## METROPOLITAN GOVERNMENT OF NASHVILLE AND DAVIDSON COUNTY

### STAFF RECOMMENDATION 3956 Woodlawn Drive July 18, 2018

**Application:** New Construction—Infill and Outbuilding  
**District:** Woodlawn West Neighborhood Conservation Zoning Overlay  
**Council District:** 24  
**Map and Parcel Number:** 11604000100  
**Applicant:** Chris Goldbeck, P. Shea Designs  
**Project Lead:** Melissa Baldock, melissa.baldock@nashville.gov

Figure 1. The former parcel at 200 Ensworth, seen from Ensworth Avenue.

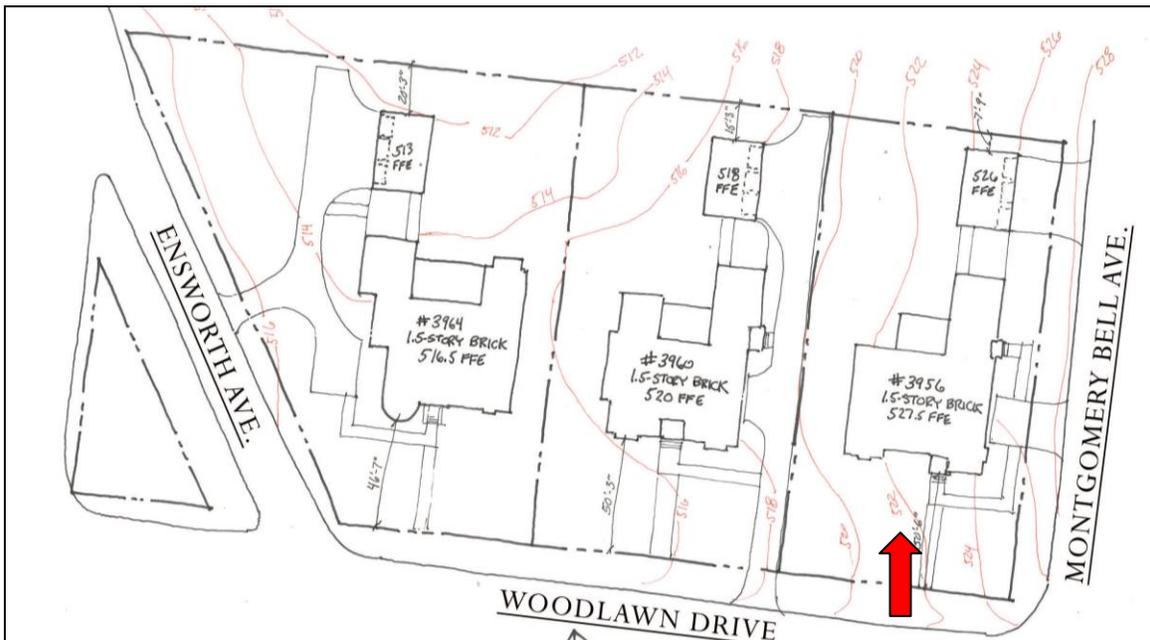
**Background:** 3956 Woodlawn Drive is one of three lots that was formerly part of the parcel previously addressed as 200 Ensworth (Figure 1). The existing house on the parcel is non-contributing, and MHZC staff issued an administrative permit to demolish it in June 2018. The existing house sat on three former lots, and the owner of the parcel has reestablished the lot lines, each facing Woodlawn Drive (Figure 2) with new Woodlawn addresses. There are no other houses in the Woodlawn-West Neighborhood Conservation Zoning Overlay that are oriented to Woodlawn Drive; therefore, Staff looked to the houses on Kimpalong Avenue and Ensworth Avenue for context.

Figure 3. Suggested area to relocate the guest parking.

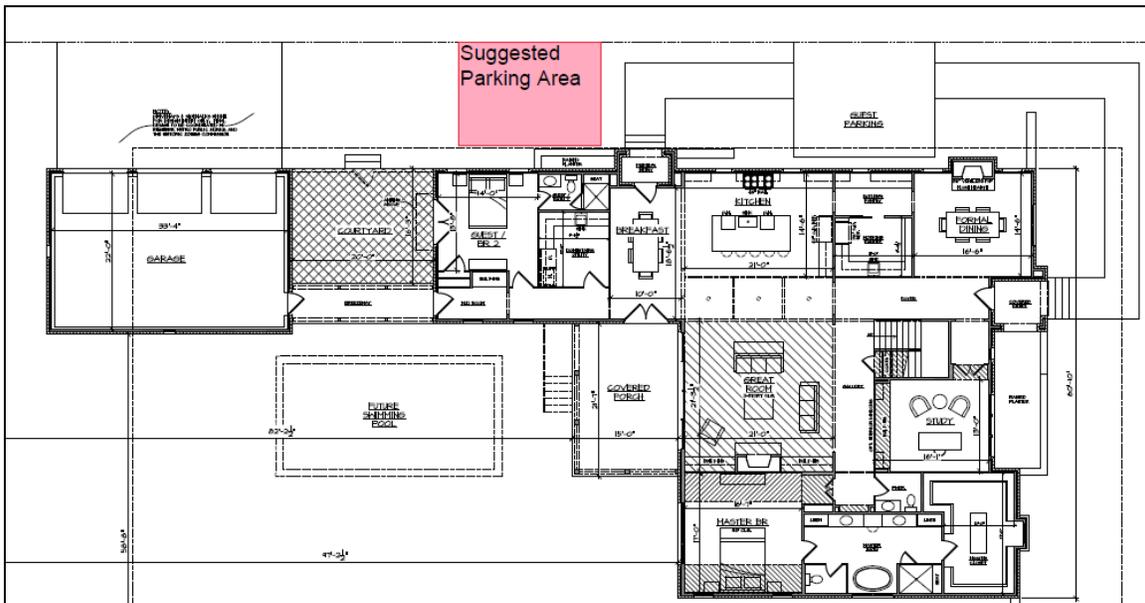
Vehicular access to the site will be via new curb cuts off of Montgomery Bell Avenue. The curb cut leading to the garage is appropriate because it is located at the rear of the lot. The other curb cut, for guest parking, is located just fifteen feet (15’) from the front wall of the house. Staff finds this location to not be appropriate. There is no street parking permitted on Woodlawn, Ensworth, and Montgomery Bell Avenues, so staff finds that additional uncovered parking for guests could be appropriate off of Montgomery Bell Avenue. However, staff recommends that it be located on the other side of the “Friends Entry” so that it is towards the rear half of the lot (Figure 3). With this recommendation, staff finds that the house’s orientation meets Section II.B.1.f. of the design guidelines.

SITE PLAN  
1:40

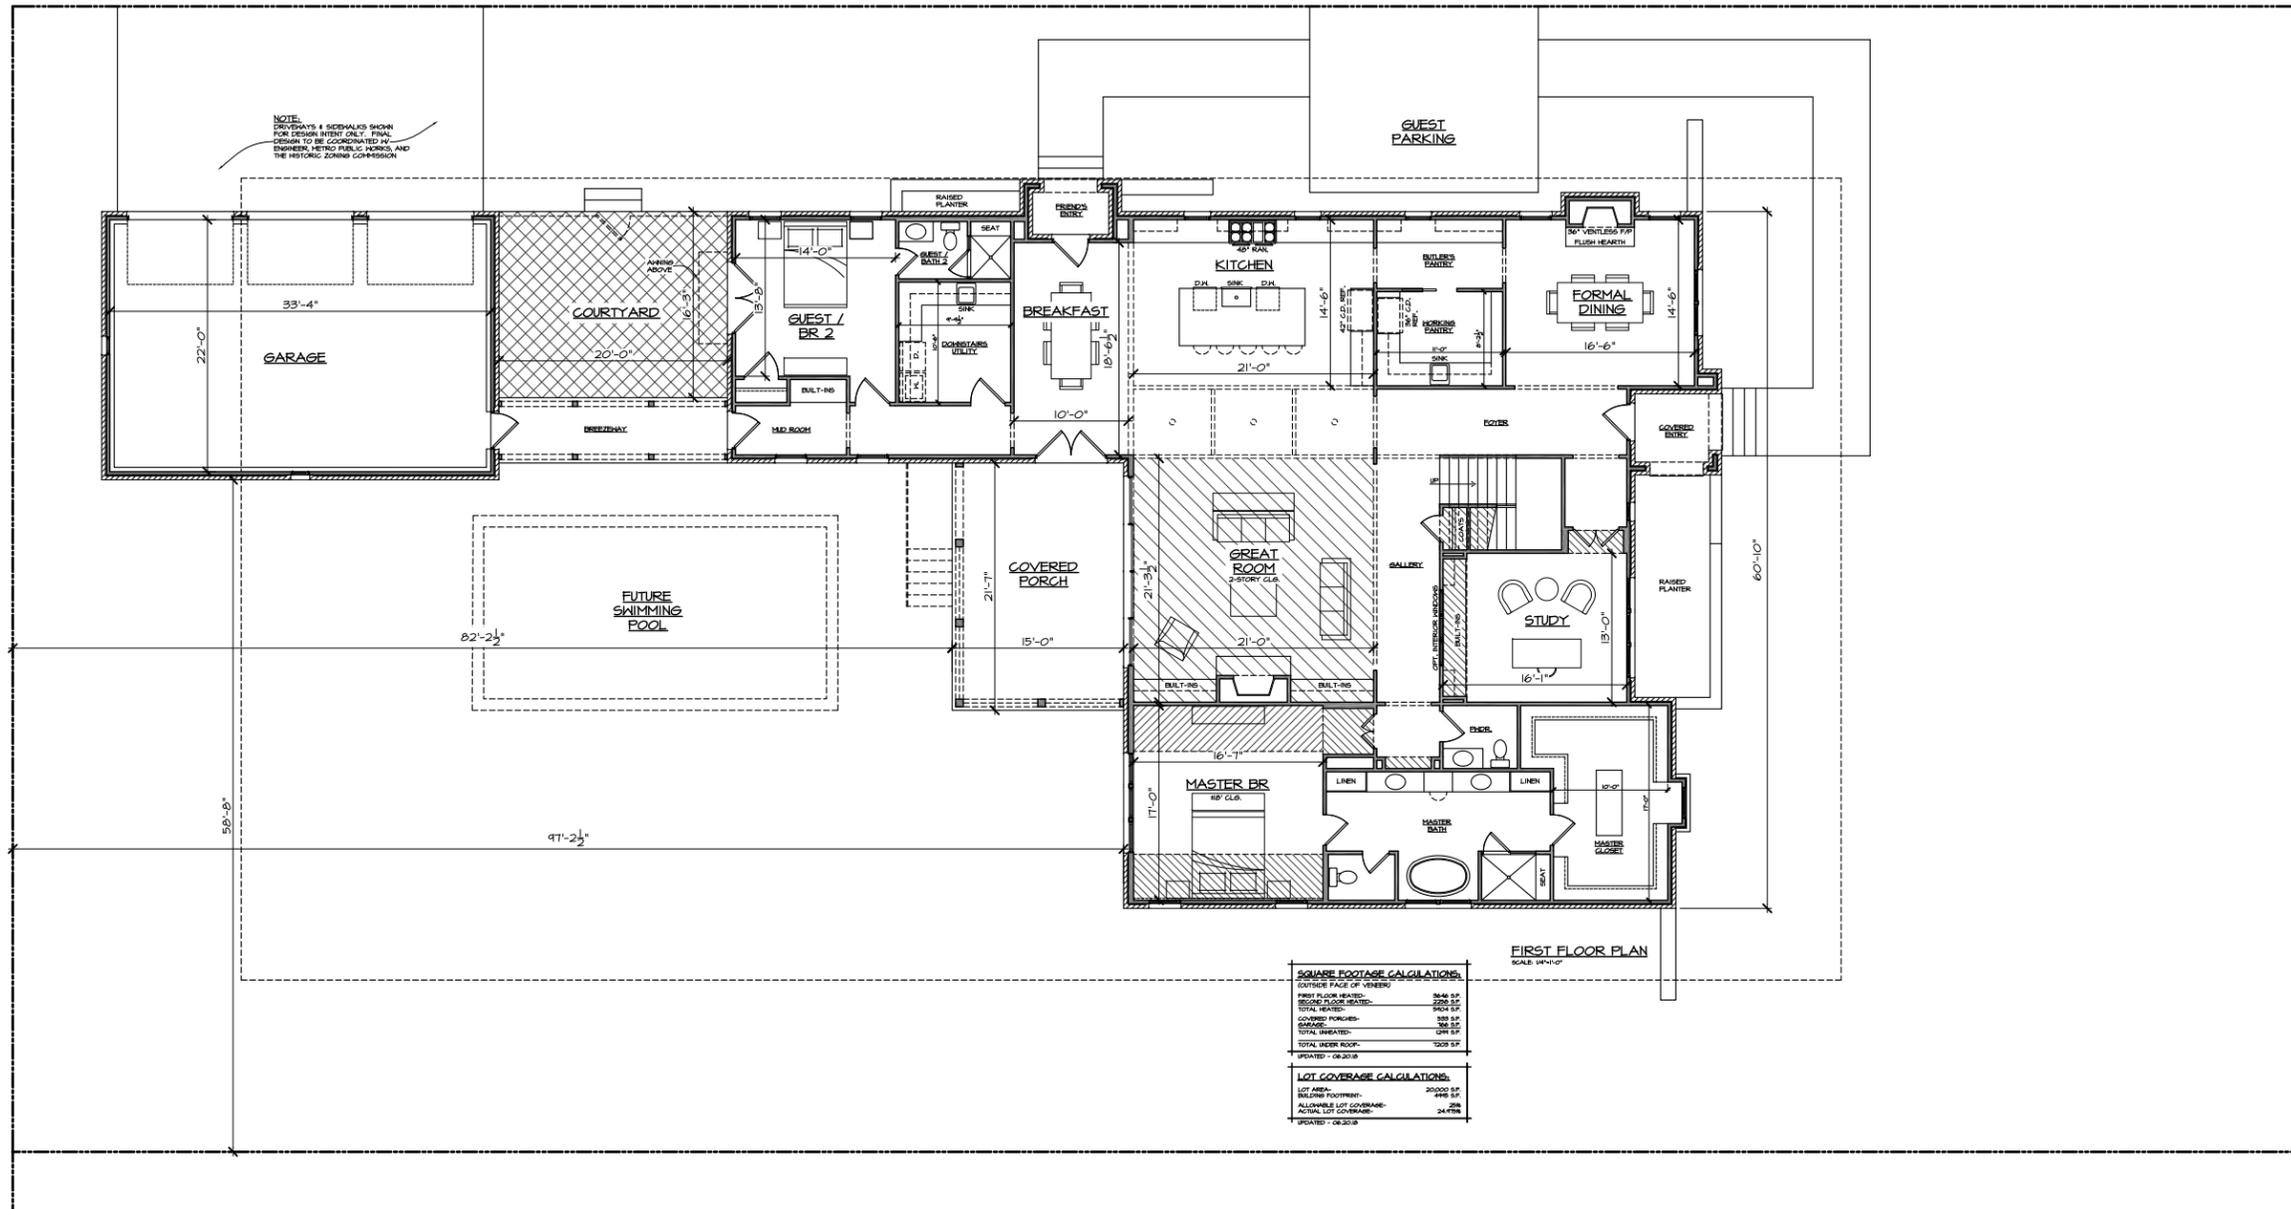
Setback & Rhythm of Spacing: There are no houses within the Woodlawn West Neighborhood Conservation Zoning Overlay that face Woodlawn Drive, and the houses outside of the overlay on the other side of Montgomery Bell Avenue are on deeper lots. There is no established front setback. The applicant is proposing to situate the infill about fifty feet, six inches (50'6") from the front property line, which staff finds to be appropriate.

The bulk of the infill is drawn so that it will be approximately eighteen feet (18') from Montgomery Bell Avenue side property line, although the "Friends Entry" is fifteen feet (15') from the side property line. Base zoning requires a twenty foot (20') side setback for the infill, so the proposed setbacks do not meet base zoning. The applicant has agreed to shift the infill back five feet (5') so that it meets the base zoning setbacks. Even with this shift, the infill will meet the side setback on the interior property line. Base zoning requires a fifteen feet (15') setback off of the interior side property line. The drawings currently show a twenty-one feet (21') setback, and with the shift, it will be approximately sixteen feet (16') from the side property line.

The infill will be approximately sixty-two feet (62') from the rear property line. With the condition that the infill be a minimum of twenty feet (20') from the Montgomery Bell Avenue side property line, staff finds that the proposed setbacks and rhythm of spacing meet Section II.B.1.c. of the design guidelines.

\* Base zoning requires a twenty foot (20') side setback from Montgomery Bell Avenue. The applicant has agreed to shift the garage back two feet (2') in order to meet the base zoning setbacks. With the condition that the outbuilding be a minimum of twenty feet (20') from the Montgomery Bell Avenue property line, staff finds that the outbuilding's site planning and setbacks meet Section II.B.h.2 of the design guidelines.

LEFT SIDE ELEVATION  
 SCALE: 1/4" = 1'-0"

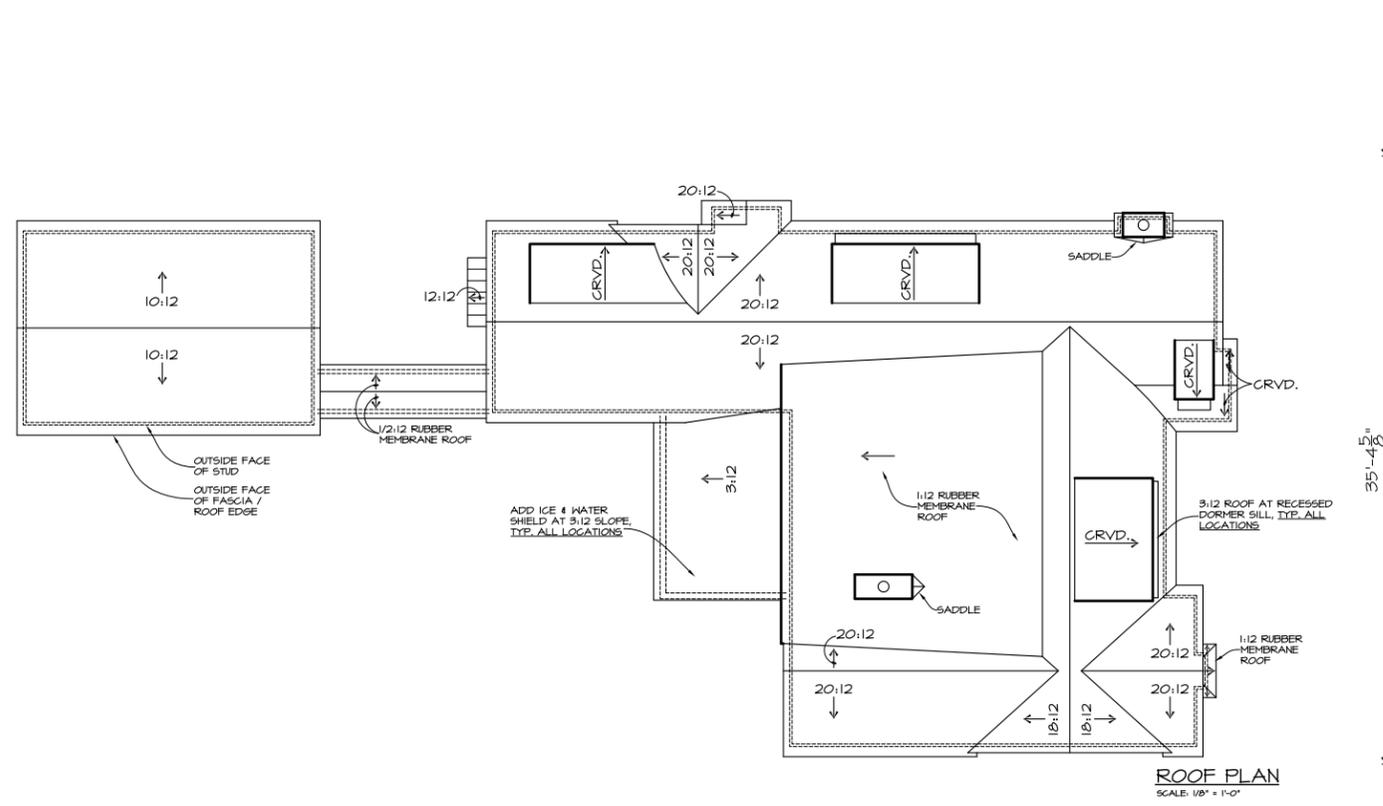
\*The applicant is proposing brick to grade. MHZC typically requires that there be a change in material from the foundation to the wall above. Staff recommends that the foundation be stone, stucco, or split face concrete block.

\*\*Staff recommends that the cedar siding be smooth and not rough sawn.

**Roof form:** The infill’s primary roof form is a cross gable with a slope of 18/12 on the side and 20/12 at the front. The front and side dormers have curved shed forms and are all inset a minimum of two feet (2’), as is required. Staff finds that the infill’s roof forms are compatible with the historic context and meet Section II.B.1.e. of the design guidelines.
